BOARD ACTION REPORT – APPEALABLE ITEM

Project Name: Delray Place South
Project Location: 1911 South Federal Highway
Request: Class III Site Plan Modification
Board: Site Plan Review and Appearance Board
Meeting Date: August 14, 2019

SITE PLAN REVIEW AND APPEARANCE BOARD STAFF REPORT

File No.: 2019-121-SPM-SPR-CL3

SP1.0

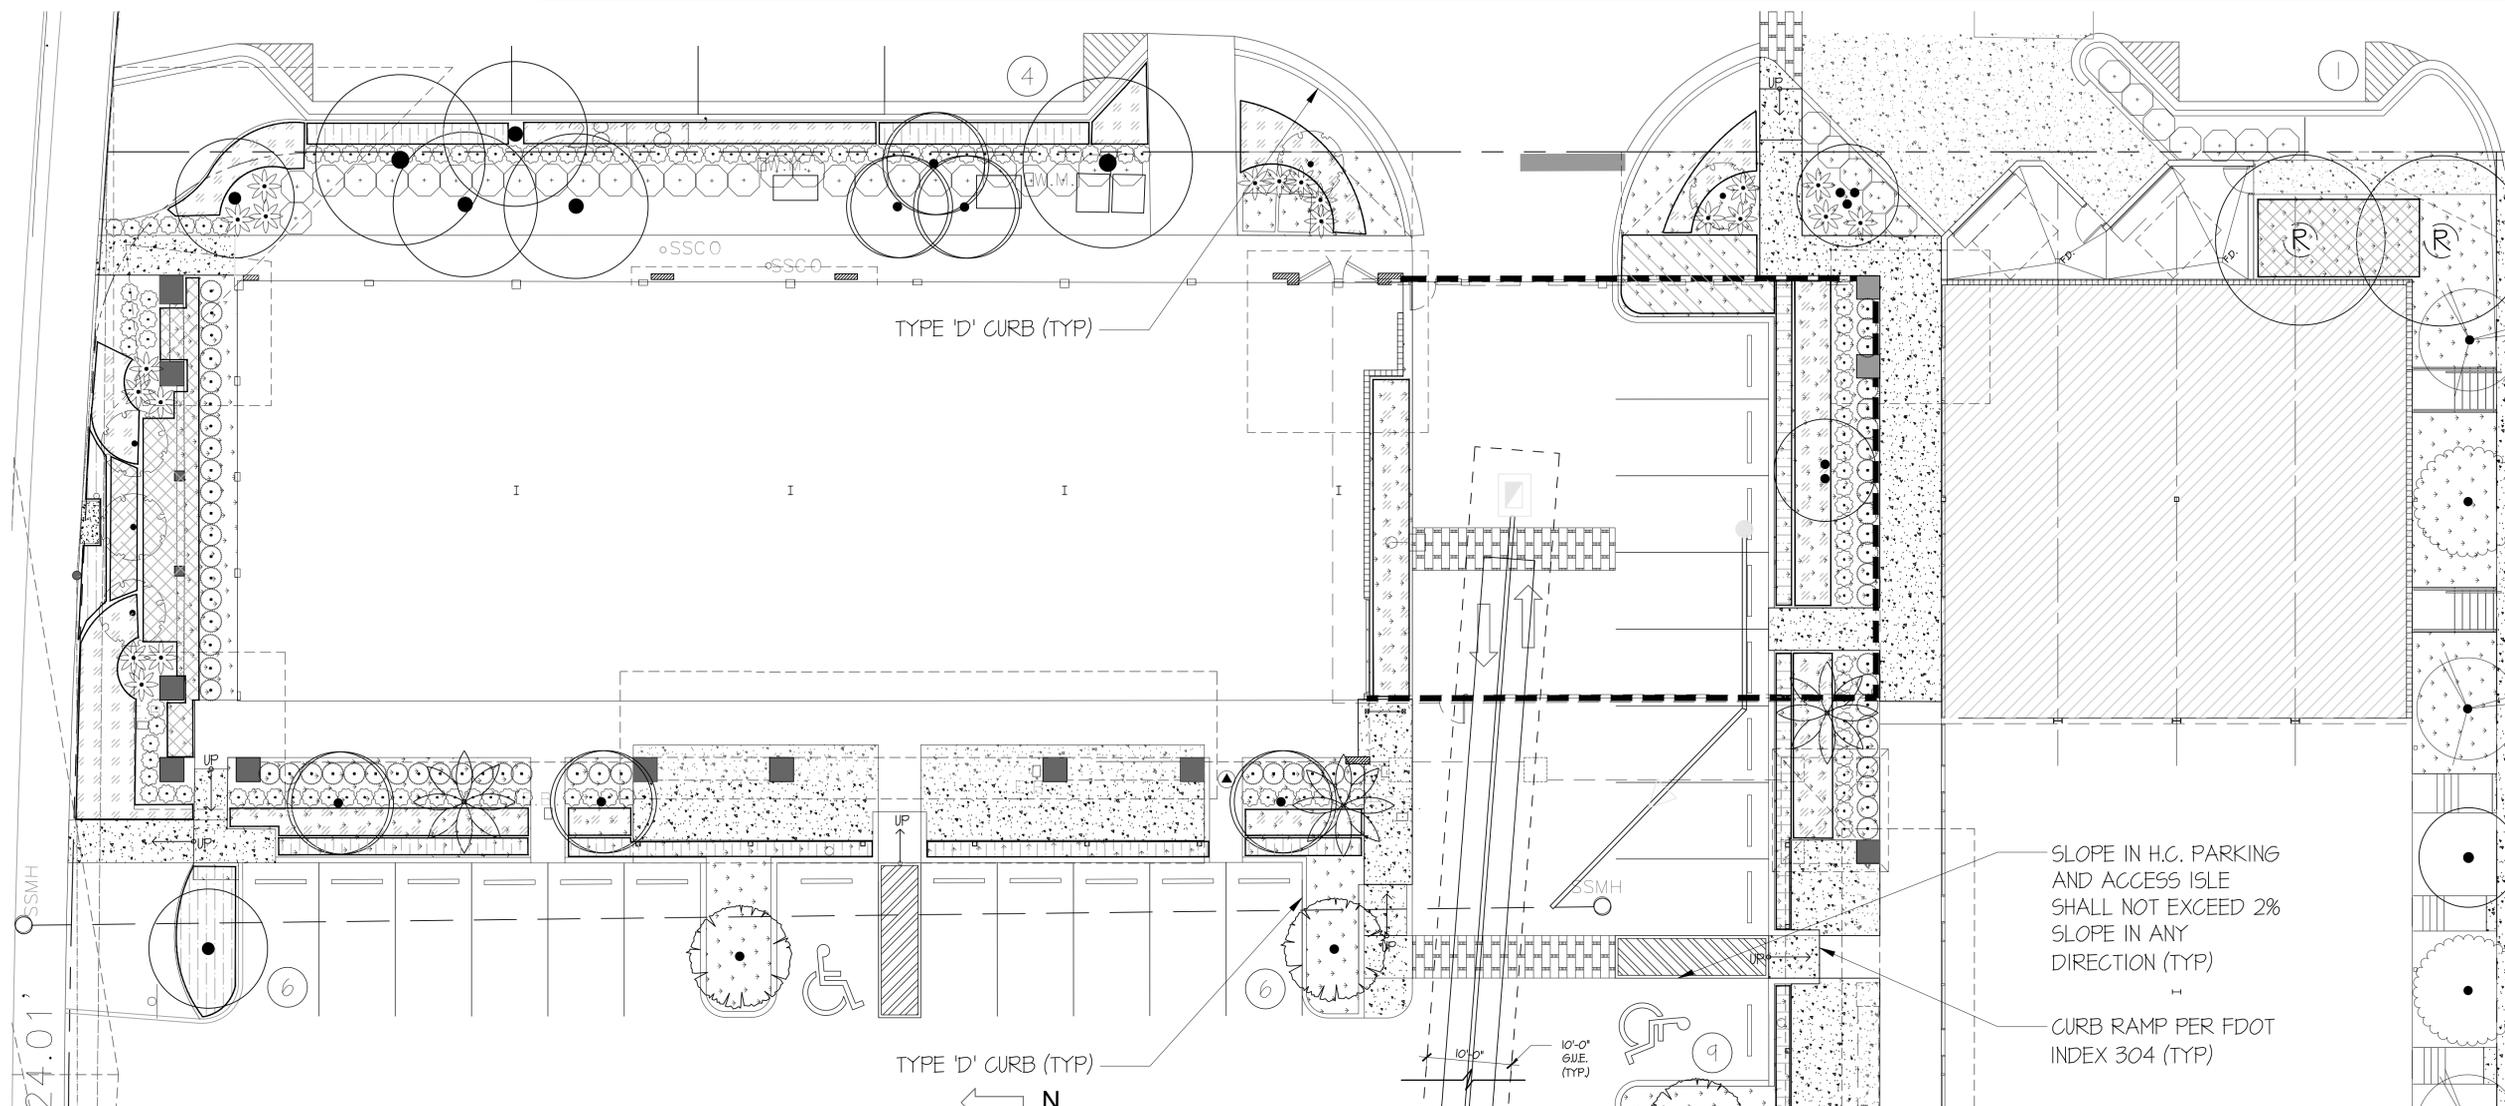
1. Revise the plans to include raised speed tables along the north/south drive aisle prior to site plan certification.

However, it should be noted that residents have concerns about improvements to allow through access from Tropic Boulevard to Eve Street. To assist in mitigating these concerns, staff is requesting that the applicant provide traffic calming devices (i.e. speed bumps) along the new two-way interior drive aisle to discourage cut-through and also reduce speeds interior to the plaza for the safety of their patrons and this is added as a note. Whereas the existing Tropic Square shopping plaza has coexisted adjacent to the existing uses, no adverse effect is anticipated. The subject site contains an existing shopping plaza, thus, the proposed redevelopment of the shopping plaza will be a continuation of the current use of the site. With the provision of traffic calming devices along the interior drive aisle connector, potential adverse impacts can be mitigated. As such, positive findings can be made with regard to LDR Section 2.4.5(F)(5) that the site plan will be compatible and harmonious with adjacent and nearby properties, subject to raised tables for traffic calming devices to discourage cut-through from Tropic Boulevard to Eve Street and maintain safe vehicle speeds.
